PRA Well #7
March 2, 2017
Packet

**PLANNING COMMISSION
STAFF REPORT**

AGENDA ITEM: Planning File No: 004-17-DA/CU: A development application and conditional use request for a proposed new public building (a well pump house) associated with Well #7PRA.

UNIT A&C MAIN FLOOR PLAN

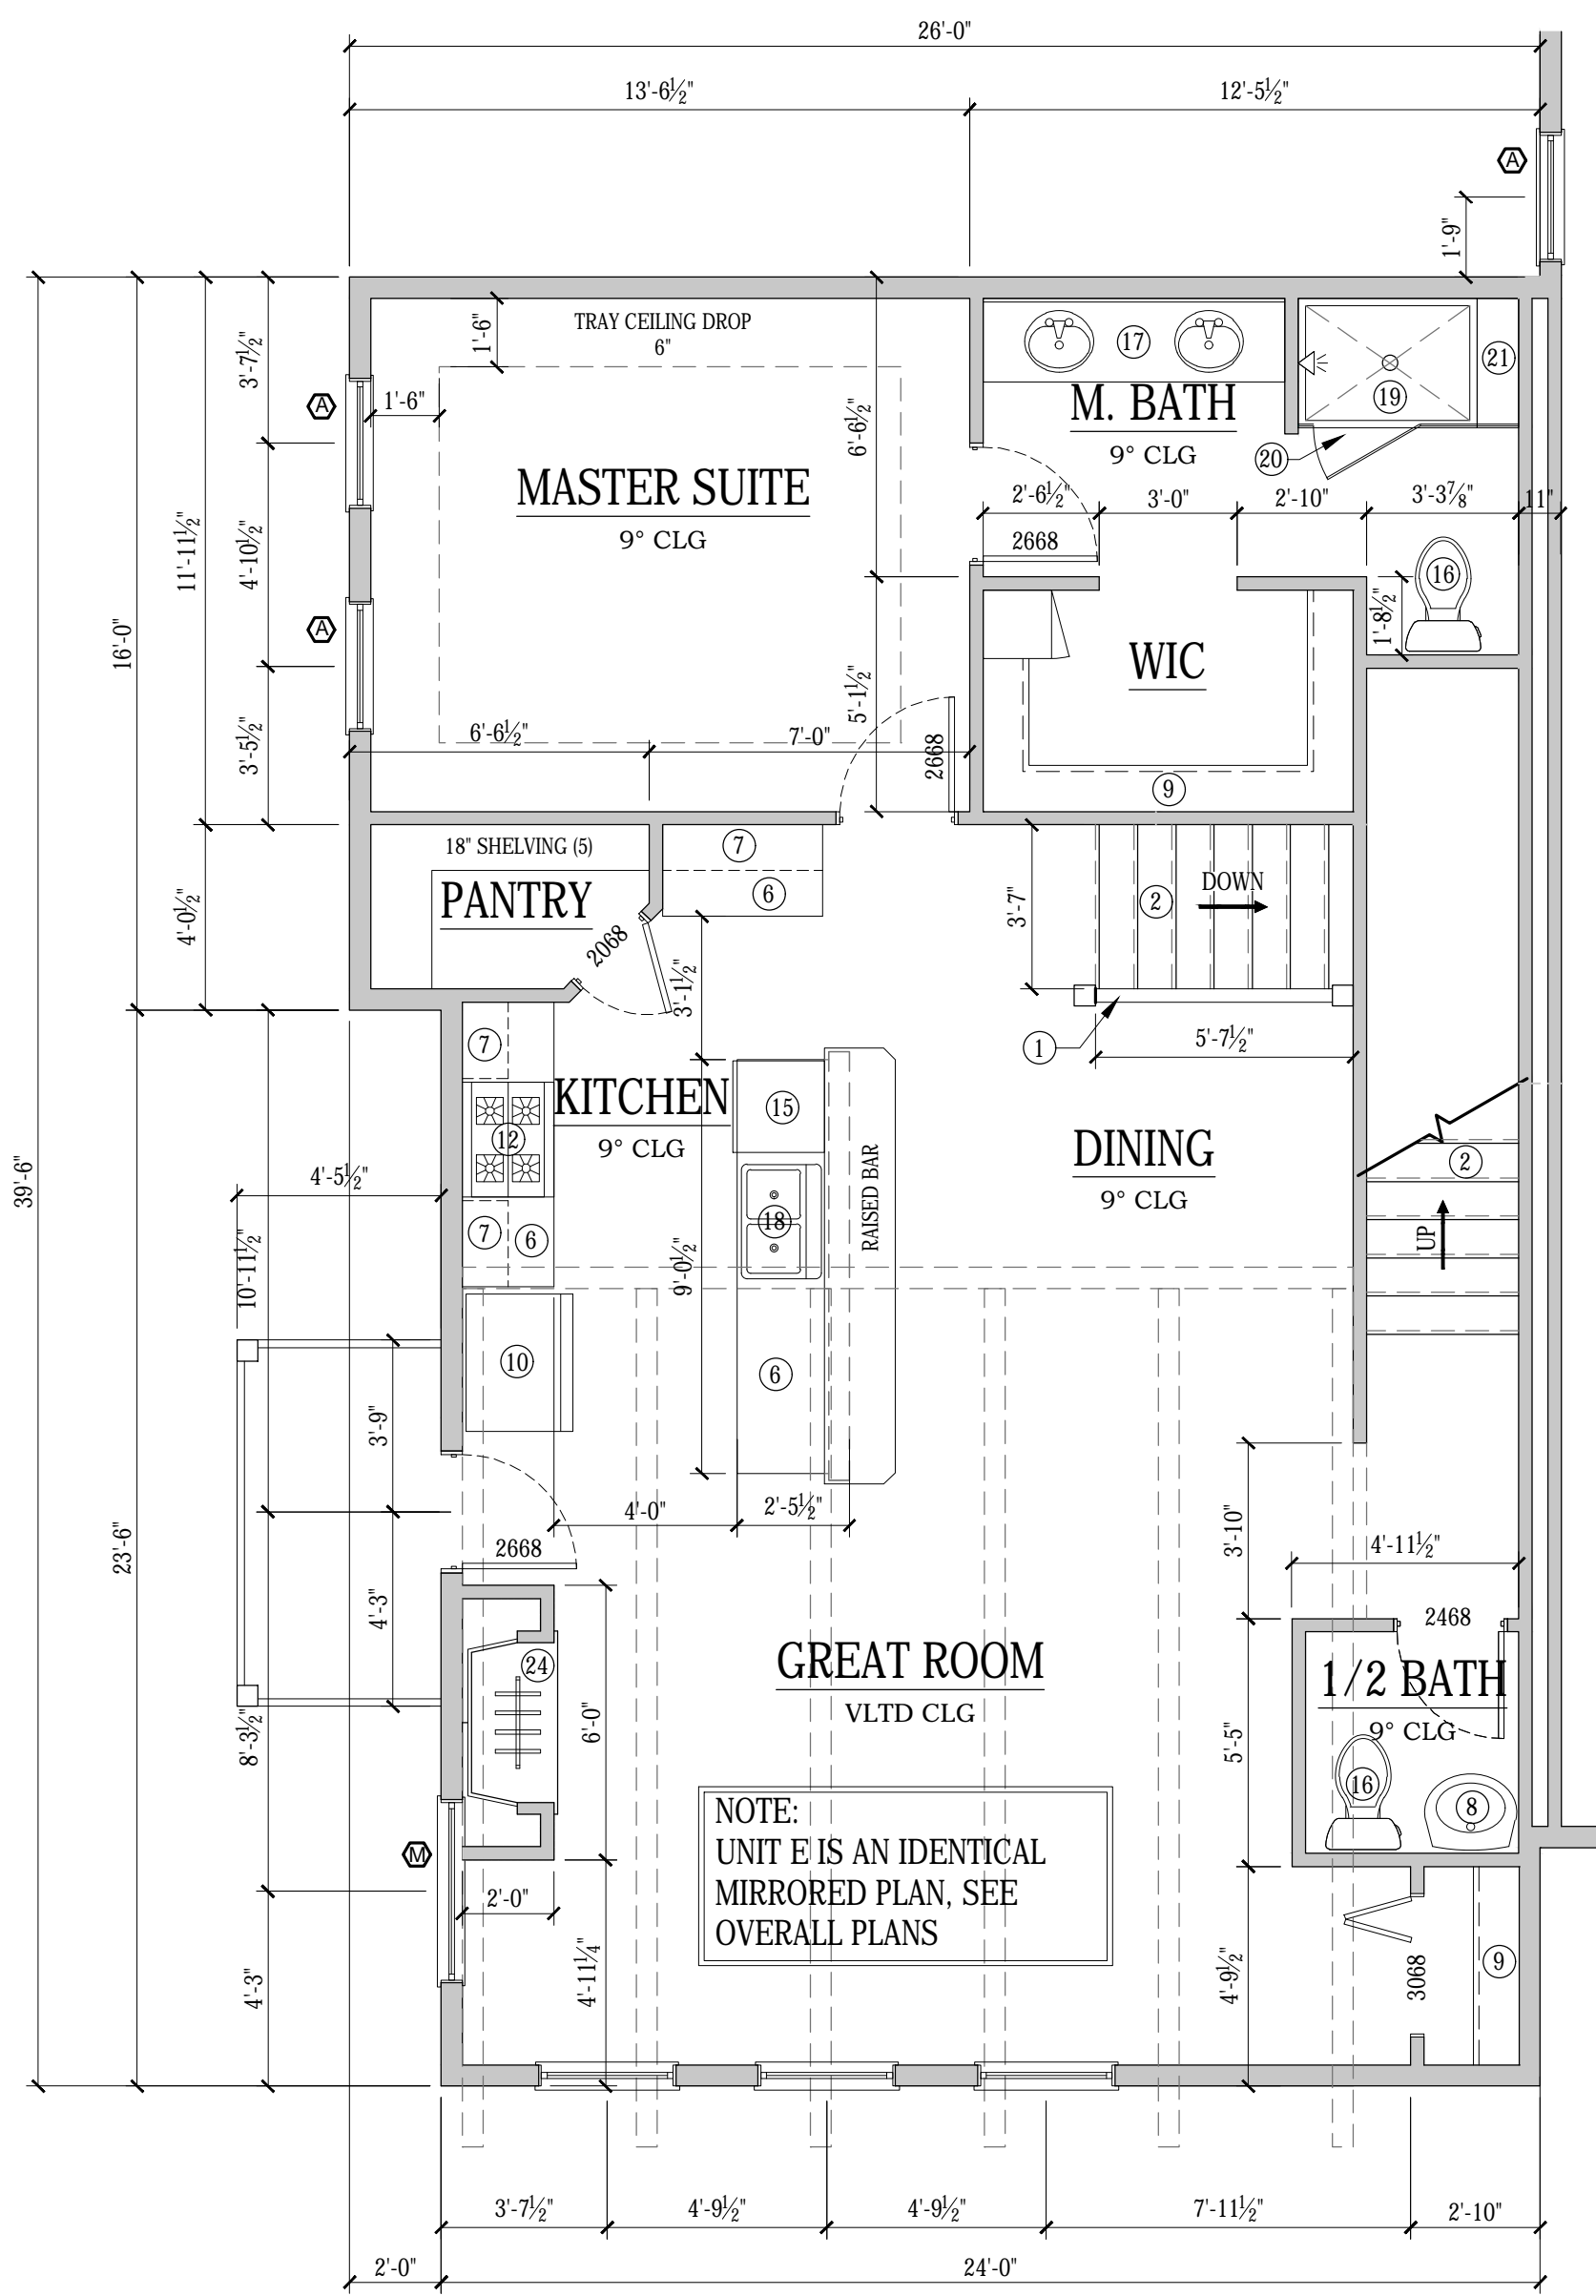
6. *The location of the fire sprinkler room shown on Sheet A1.4, Unit A & C Main Floor Plan, is not conducive to affective and efficient fire ground operations. Request a meeting with developer and architect to discuss alternative designs.*

Project: BERGMAN TOWNHOMES
 Date: 12/21/16
 Scale: 1"=10'
 Sheet: C2
 SHEET 2 OF 3

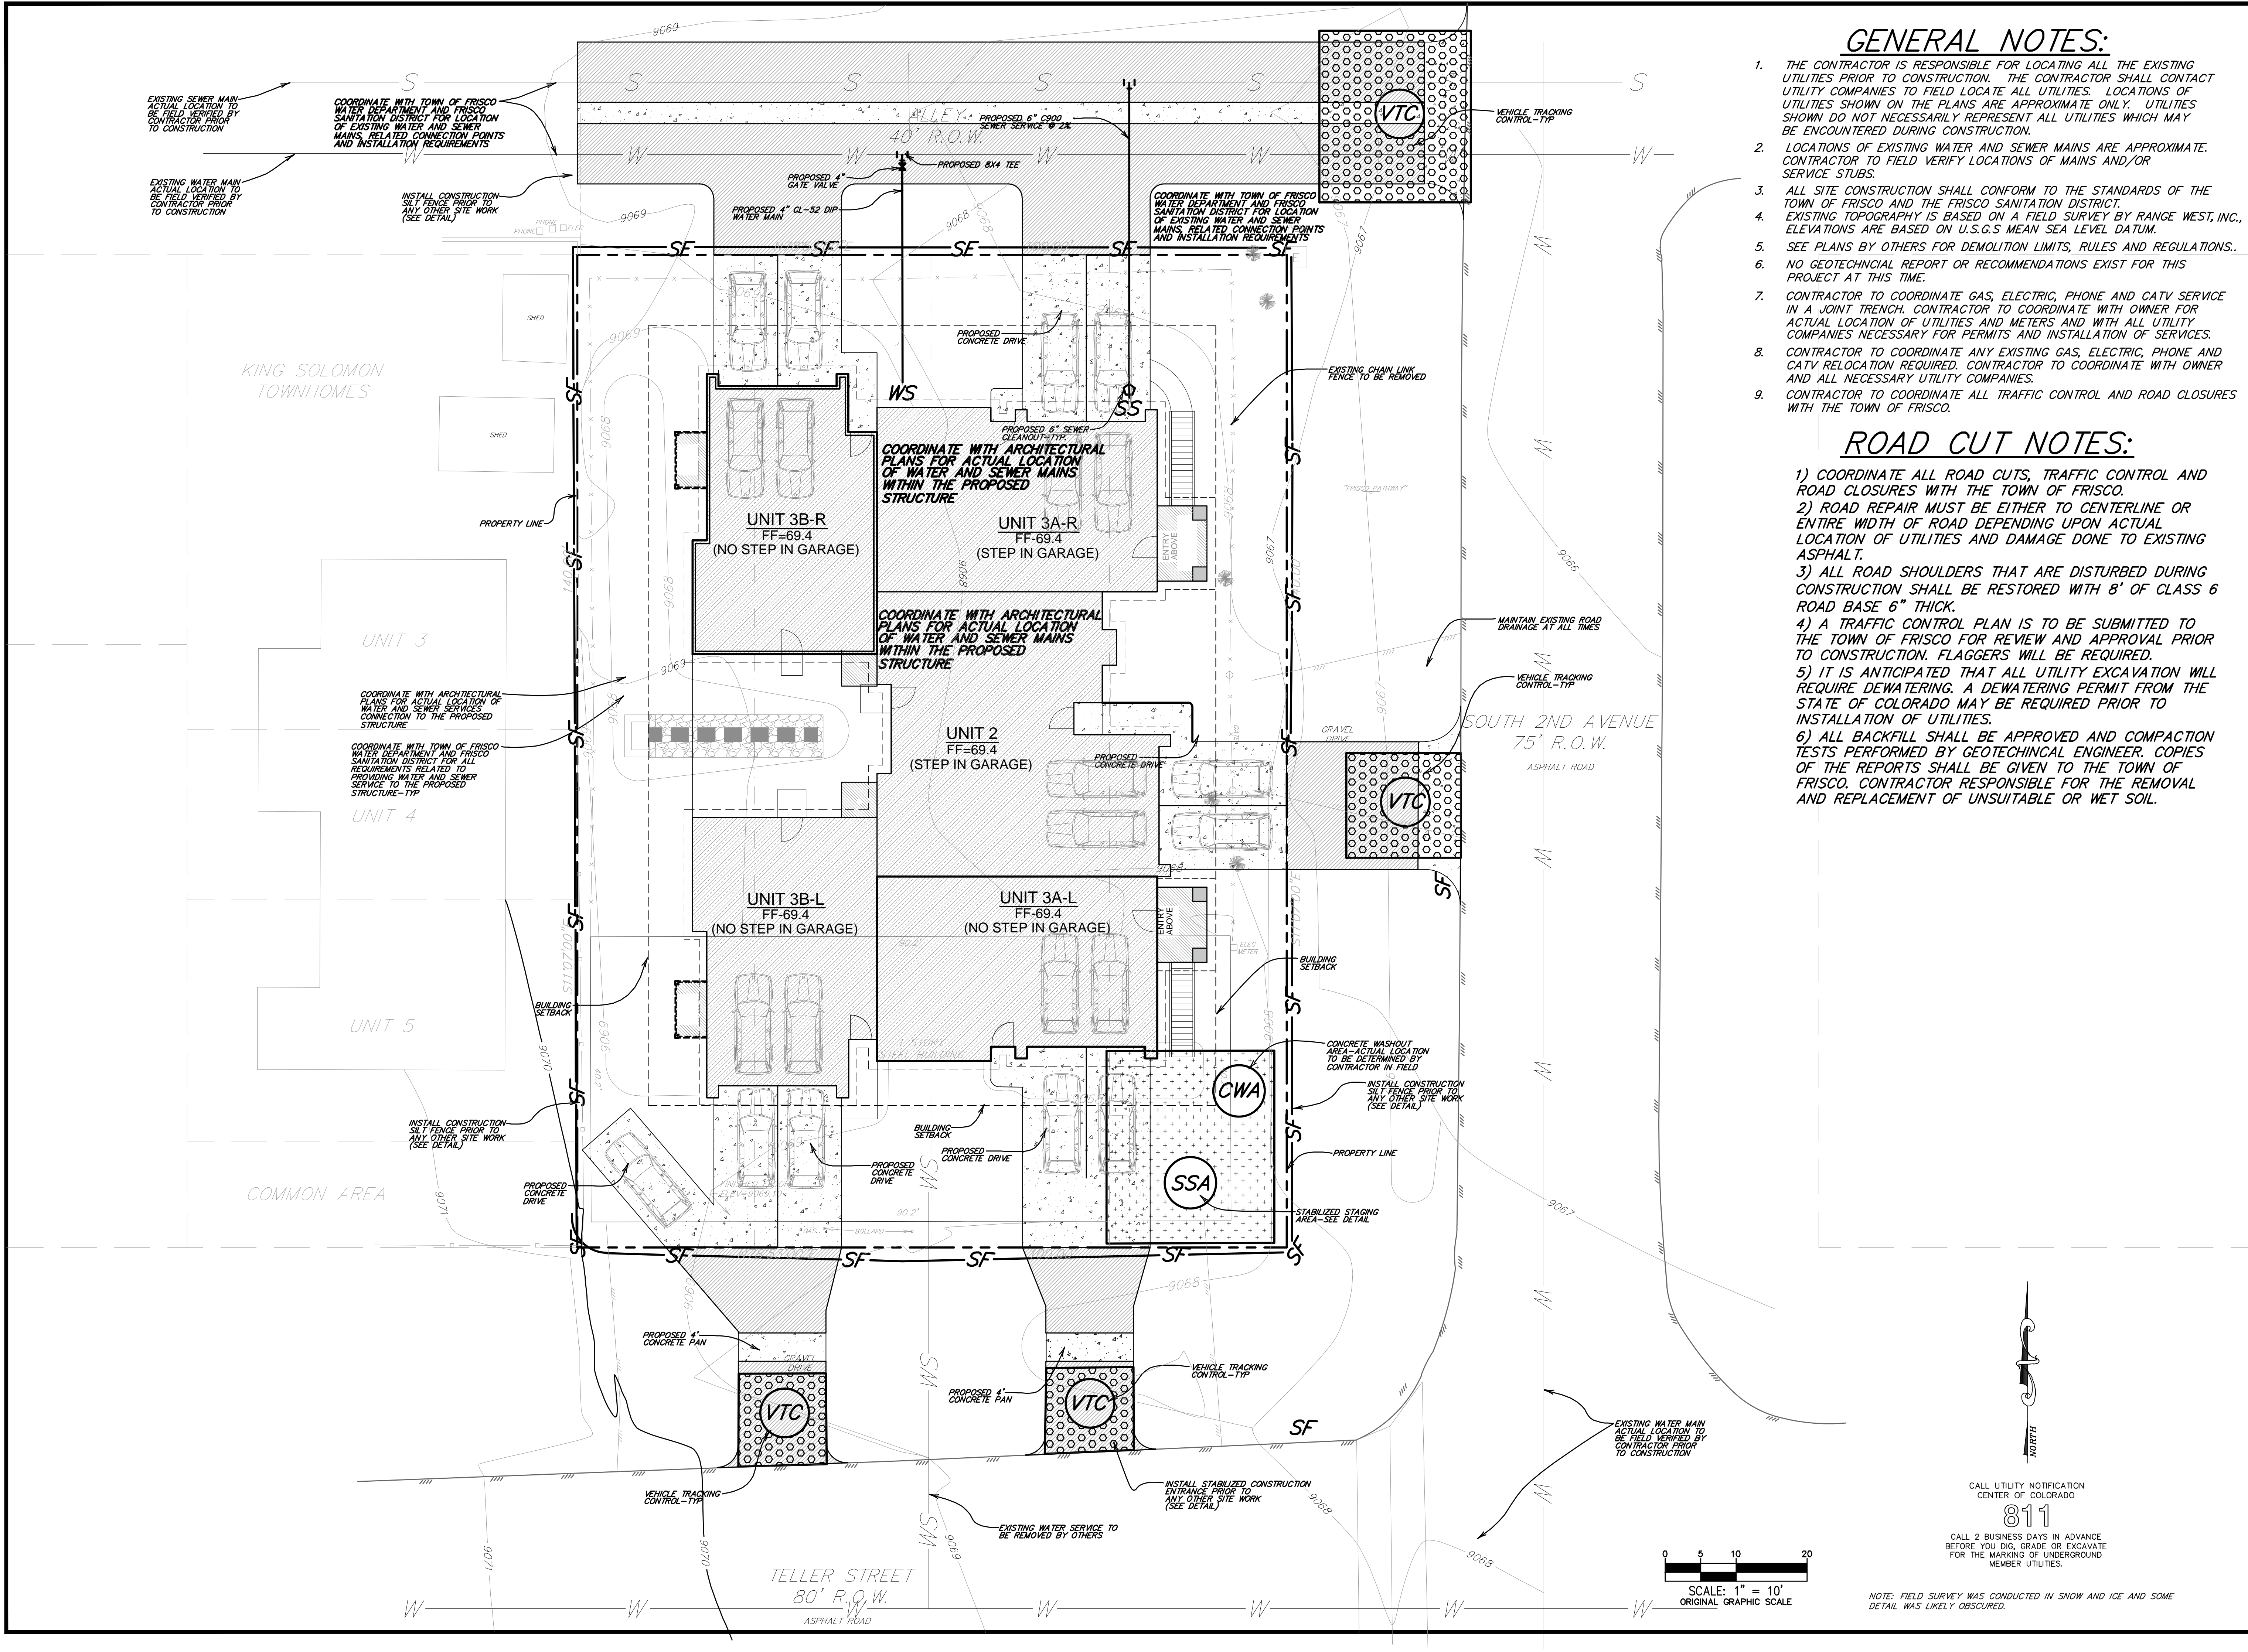
1. Sheet C2
 - a. For asphalt repair/patching, add wording to replace road base shoulders. Typical 8' CL6 6" thick shoulders are required for restoration for the entire project.
